CITY OF FISHERS AGENDA

BOARD/COMMISSION: Planned Unit Development (PUD) Committee

DATE: 12/4/2024 at 5:00 PM

a. **Atwell Suites Saxony**

Landscape Plan submitted prior to May 1 PUD Committee meeting.

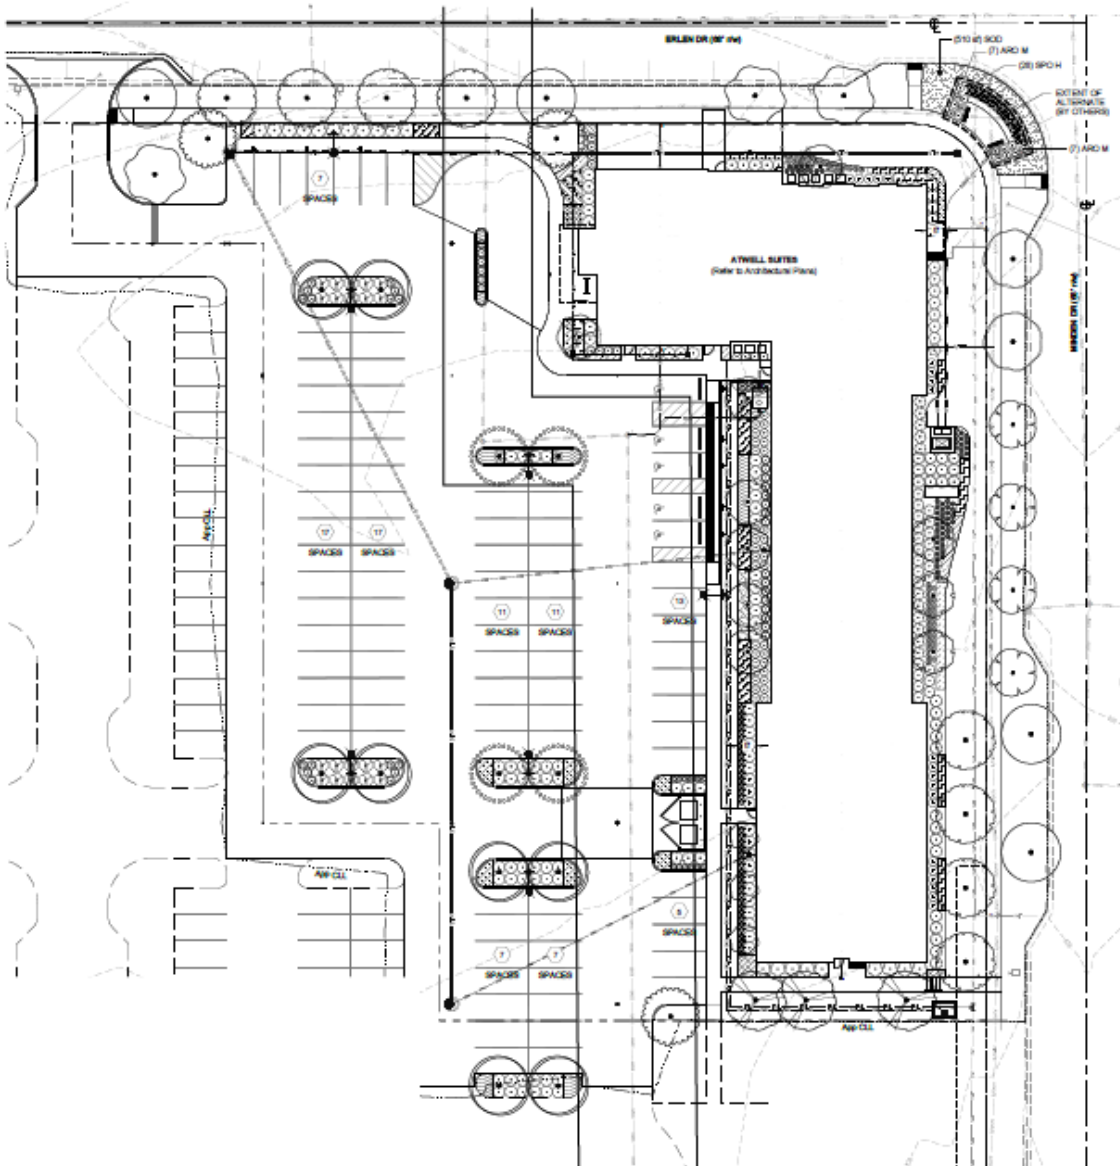
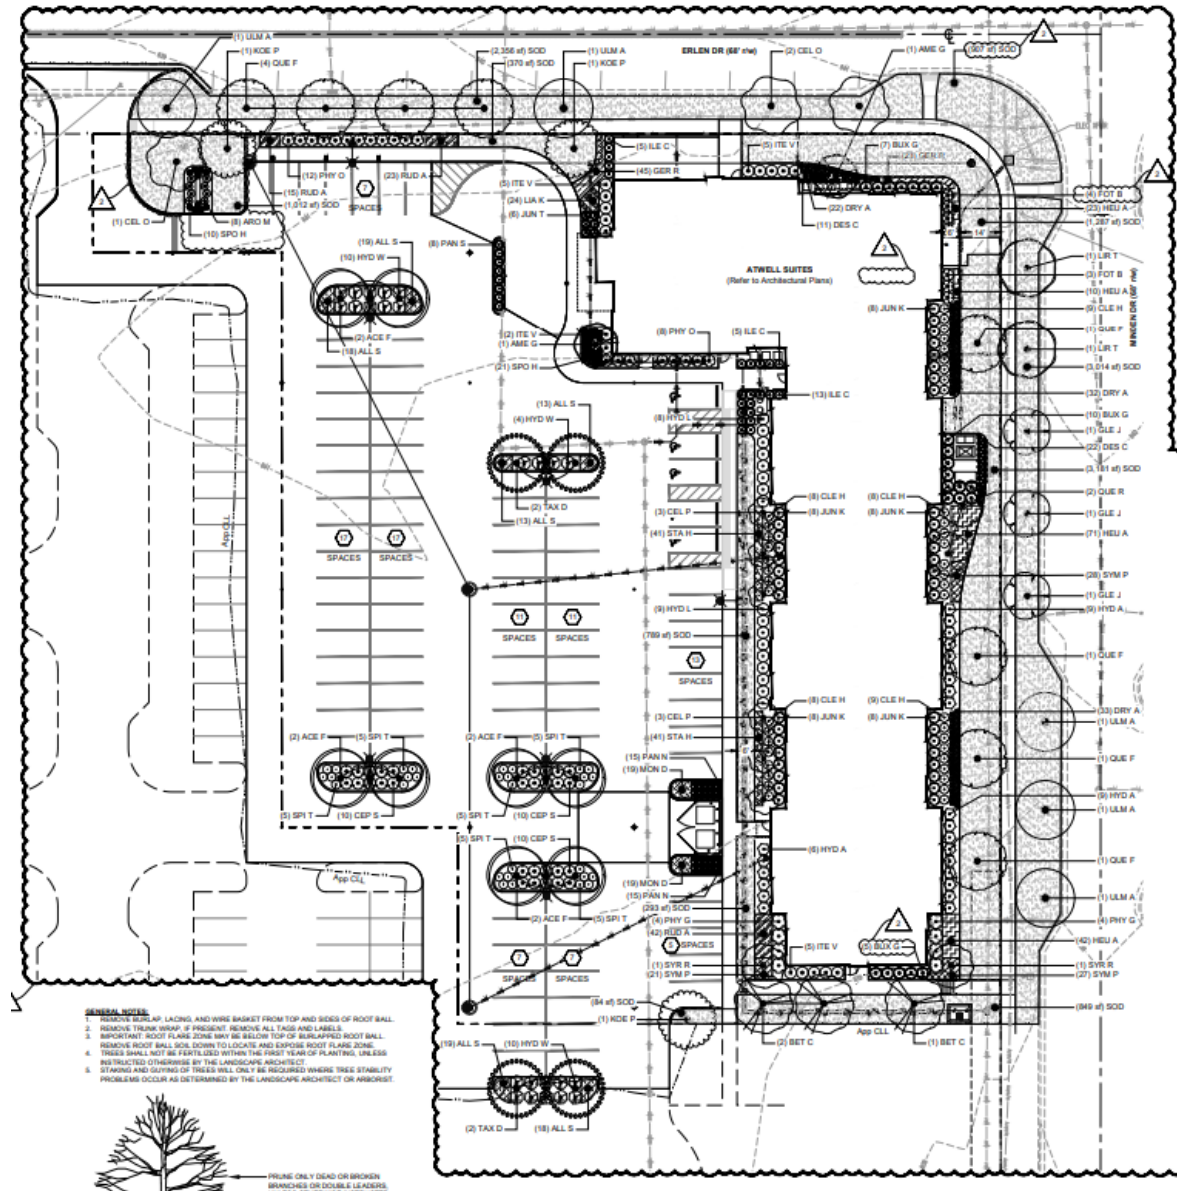
Landscape Plan submitted prior to August 7 PUD Committee meeting without proposed feature (sign at northeast corner of Minden and Erlen) and associated landscaping

Landscape Plan submitted prior to August 7 PUD Committee meeting with proposed feature (sign at northeast corner of Minden and Erlen) and associated landscaping

Landscape Plan submitted prior to November 6 PUD Committee meeting. Proposed feature at the northeast corner of the site was removed.

ATWELL SUITES, SAXONY PUD

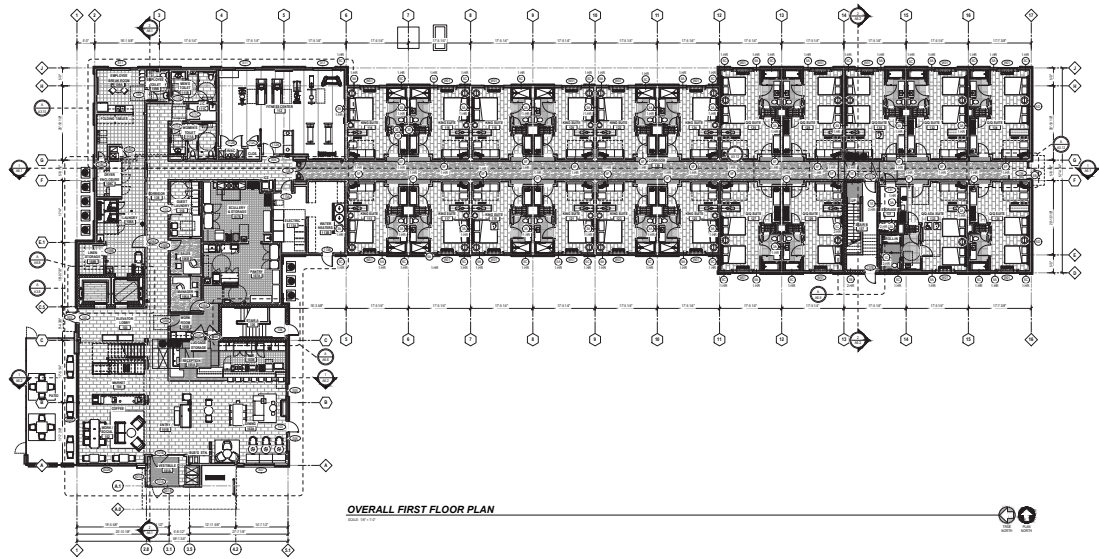
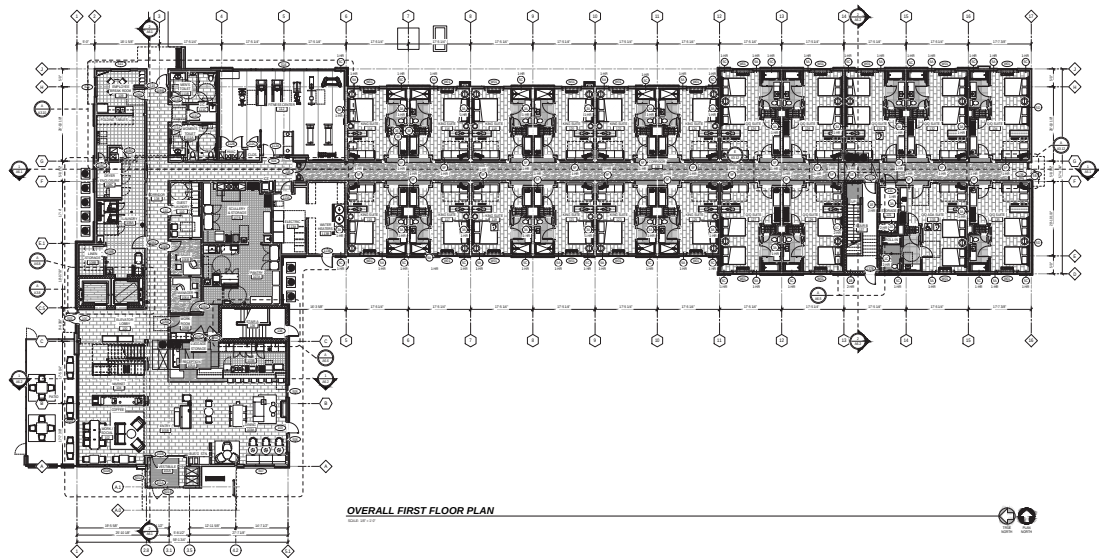
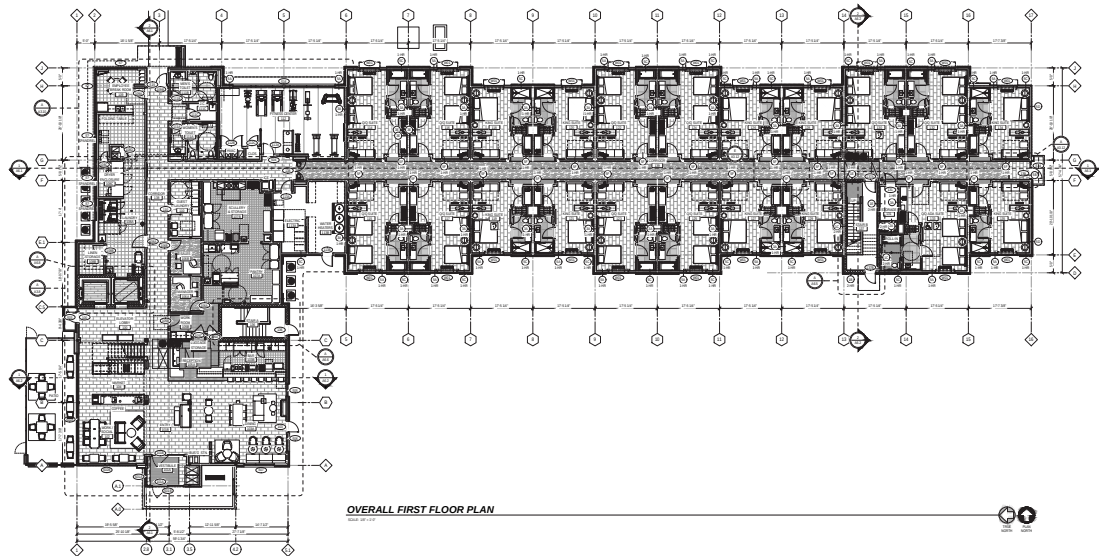
- Bump-Ins (areas of the building that are recessed): All should have masonry up to the third story and cement board on the 4th story.
- Bump-Outs (areas of the building that extend outwards): All should have masonry up to the fourth story

- Continuous modern metal awning along entire first story
- Additional glass features along northern side of building
- Add corner caps at all/near all corners of building

- Public art included on high profile blank areas on building
- Add full glass feature along north building elevation (i.e. in front of fitness center)
- Add full wrap of storefront windows

- Raise height of first floor hotel room windows to height of the fitness center windows
- Show exhibit that identifies where fake vs real windows are located

- Ensure louvers under hotel room windows blend in with surrounding materials (i.e. color of louvers match color of surrounding materials)
- Soldier course brick may be added in places where canopy cannot be added

- The floor plans have been revised and guestrooms rearranged in pairs to create a more residential undulation in the building form. This has been done on both east and west sides of the building on all 4 levels.

- Awnings have been revised to more modern metal canopies. A new canopy has been added over the Fitness Center, and the northeast entrance canopy have been expanded to wrap around the north facade. Additional and expanded awnings / shading elements to create a “continuous” datum line at the 2nd floor level.

- Faux / spandrel glass windows and storefront have been added to the north facade.
- Raised windows / added transoms along the east façade.
- Outward protruding parapets have been raised an additional 3-feet, and a “crown” / detail feature has been added to the most northern and most southern protrusions. Added / revised parapet profiles.

- Brick rowlock and soldier course details have been added at the 2nd and 4th floor levels in strategic locations.
- The proposed corner development sign has been removed.

- Added art mural to north façade.

ATWELL SUITES, SAXONY PUD

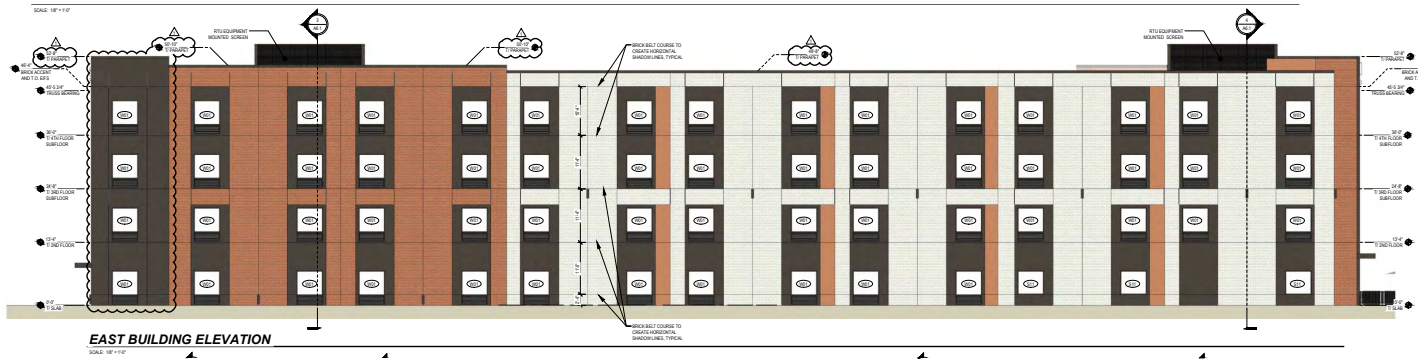
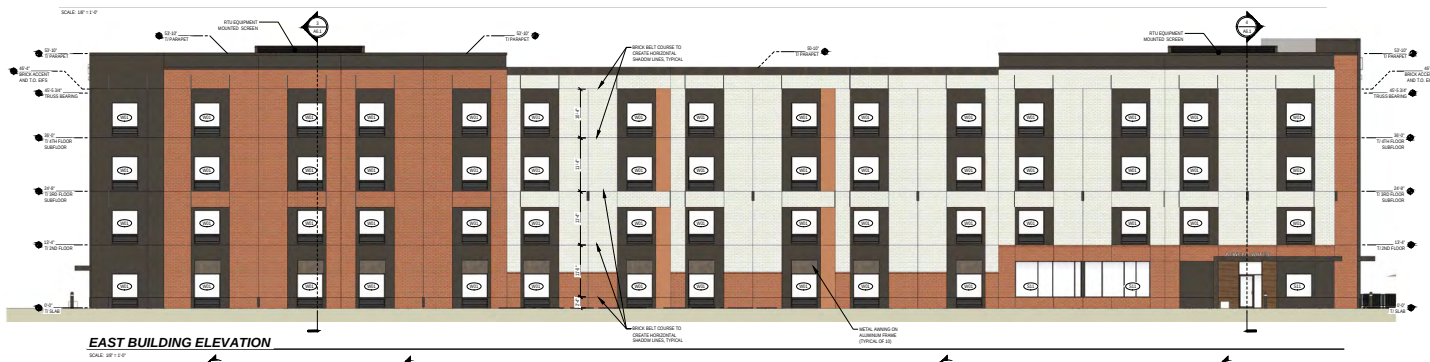
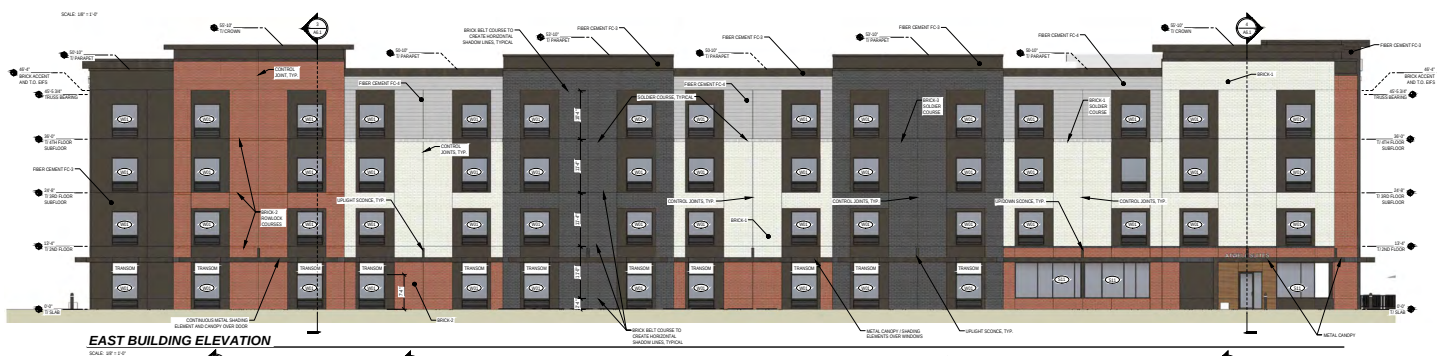
- Where there are large sections of red brick, please replace some of the red with white brick. It will provide additional color variation in those areas.
- Please include additional changes to the parapet plane with a black parapet on the northeast corner of the building.
- Please add a metal awning/ledge around entire first story facing the right of way. As an alternative, there could be a metal awning/ledge above each window on the first story. The awnings will help transition the building to the ground plane.
- As a suggestion, additional recessed LED lights could be added for visual interest, especially at night.
